ADDENDUM NO. 1

PROJECT NAME: Holcombe Drainage and Paving Improvements

PROJECT NO: WBS No. M-420126-0076-4

CHANGES TO DRAWINGS

HOLCOMBE BOULEVARD
PLAN & PROFILE
STA 1+00 TO STA 5+00

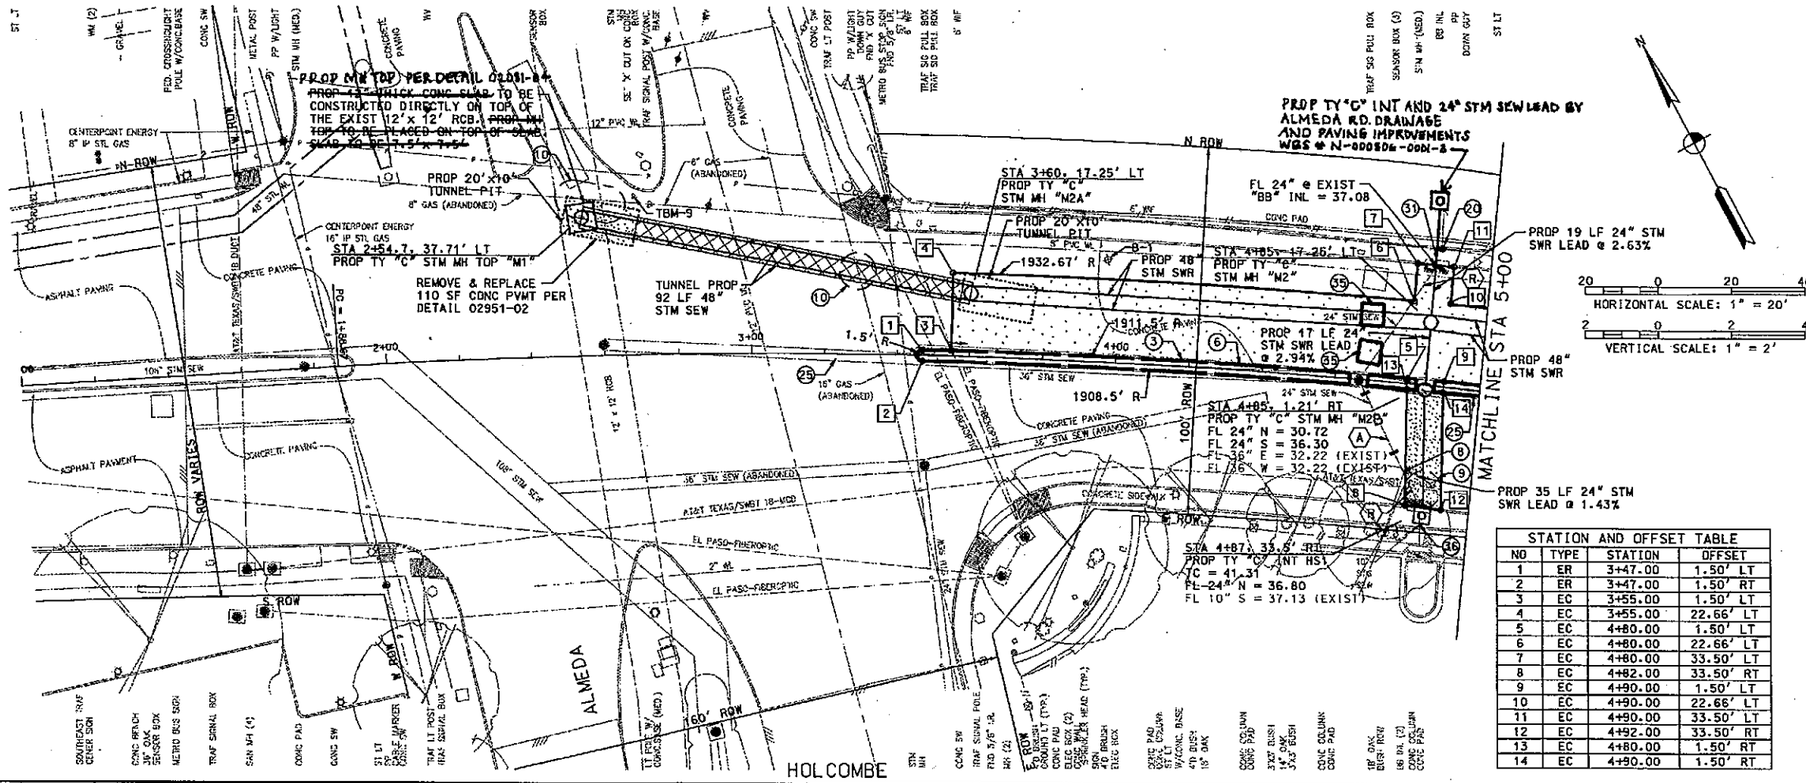
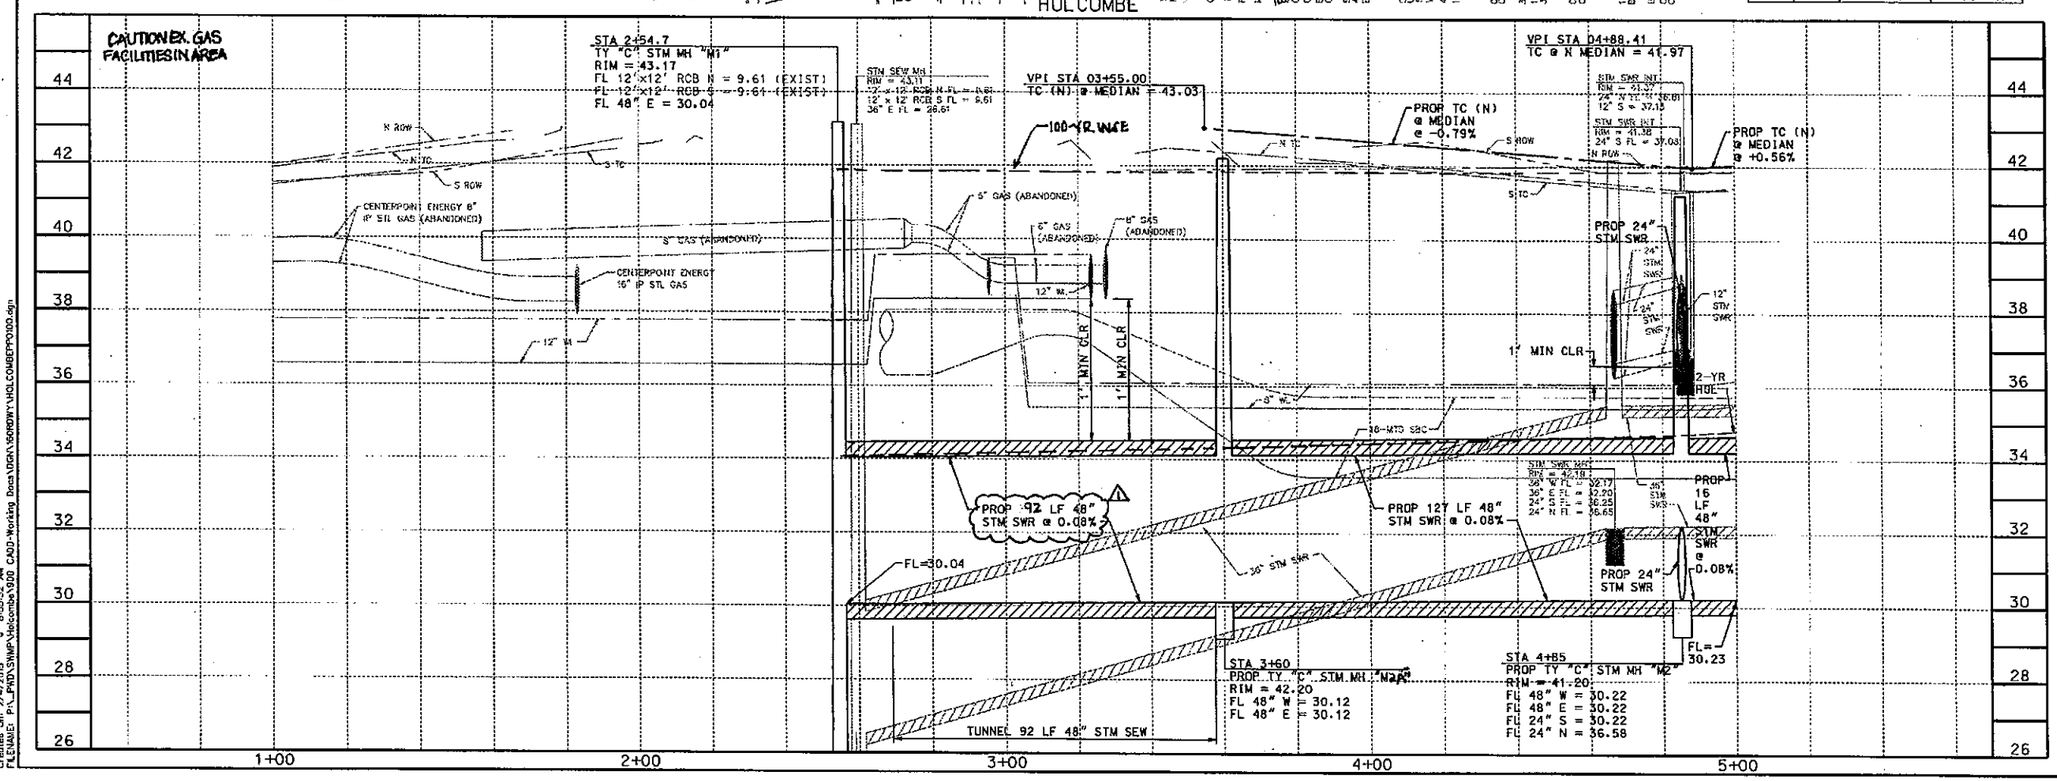
1. Drawing No.12 – Holcombe Blvd Plan and Profile Sta 1+00 to Sta 5+00
   Reason- Corrected call out for length of storm sewer by tunnel in profile view.
2. Drawing No. 60 – Holcombe Blvd Street Lighting 1 of 2-Replace entire document.
   Reason- Added electrical conduit layout.
3. Drawing No. 61 – Holcombe Blvd Street Lighting 2 of 2-Replace entire document.
   Reason- Added electrical conduit layout.

No.	Date	Revisions	Appr.
1	3/4/15	Addendum No. 1

HOLCOMBE BOULEVARD STREET LIGHTING 2 OF 2

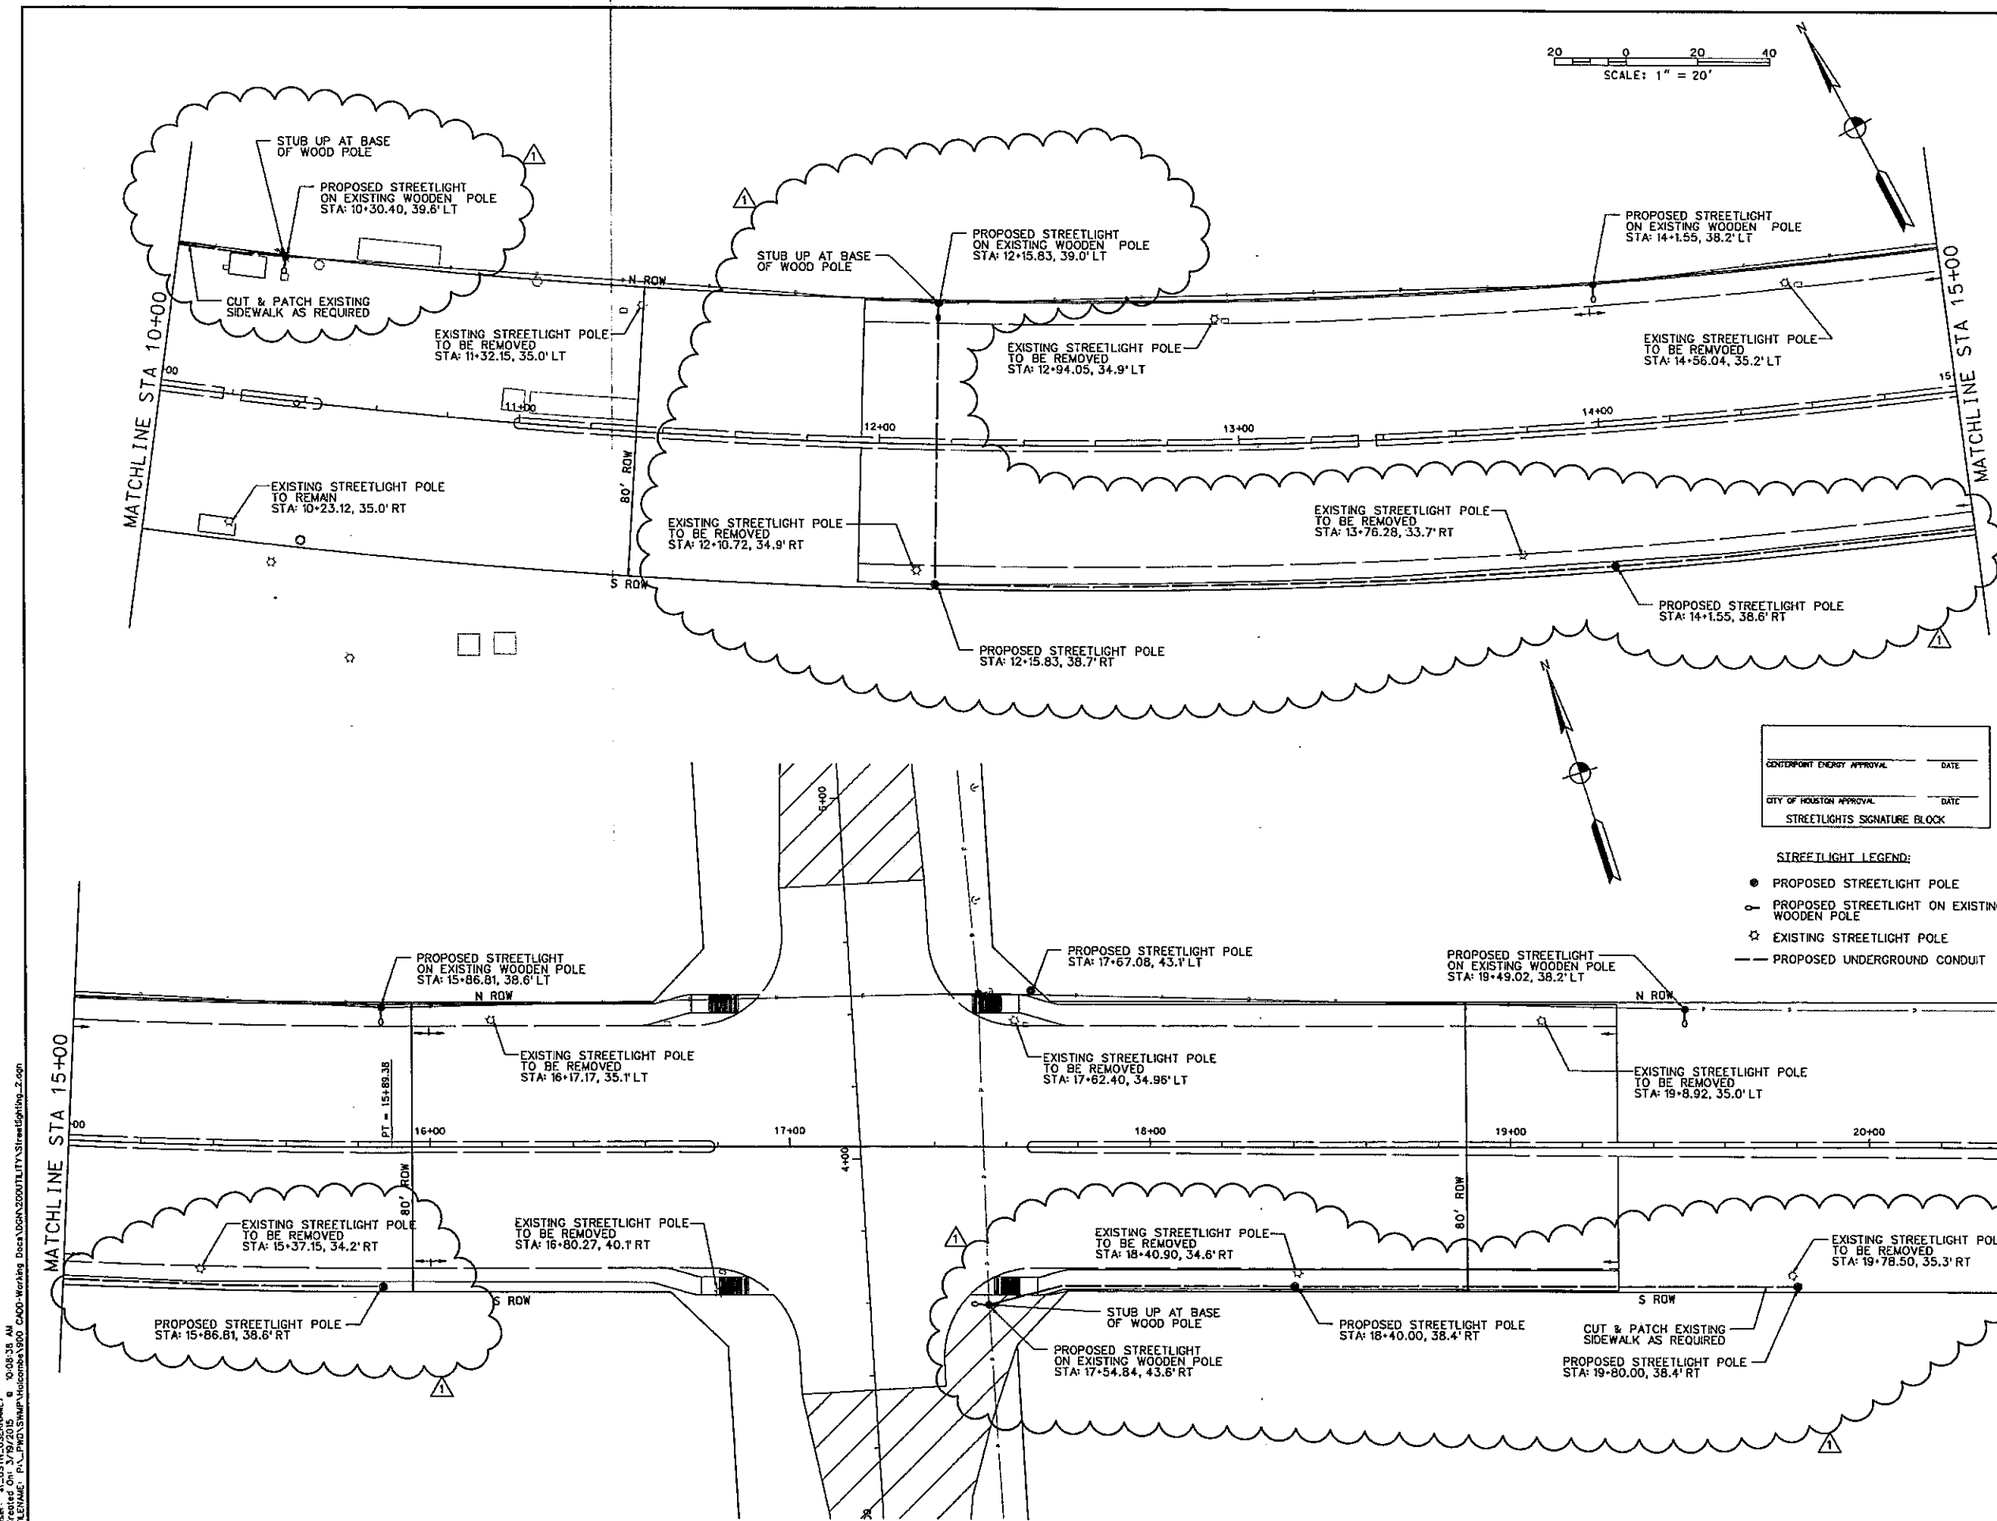
No.	Date	Revisions	APD
1	3-19-15	MODIFIED POLES AND ADDED UG CONDUIT	CJT

HOLCOMBE BOULEVARD
STREET LIGHTING
1 OF 2

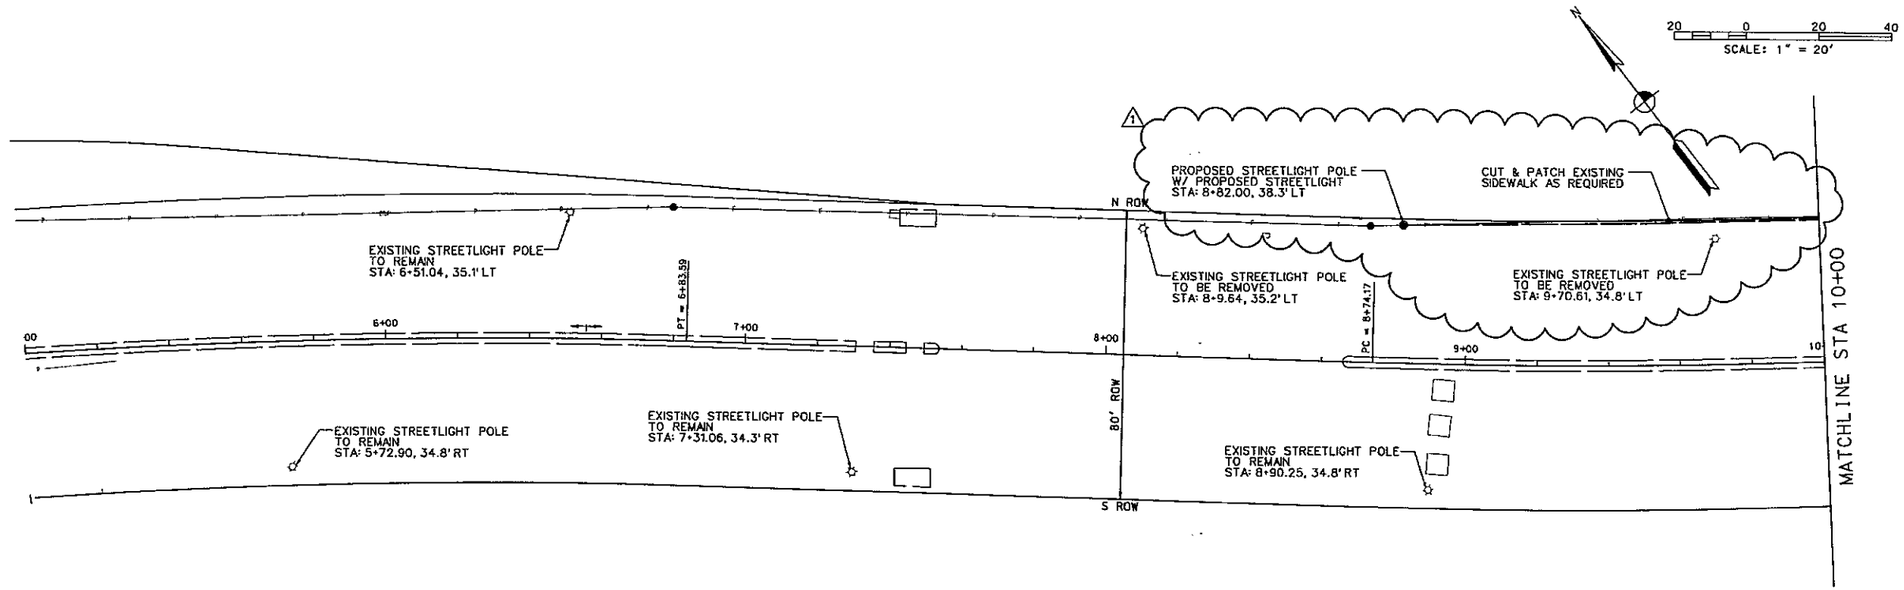
No.	Date	Revisions	APD.
1	3-19-15	MODIFIED POLES AND ADDED UG CONDUIT	CJT
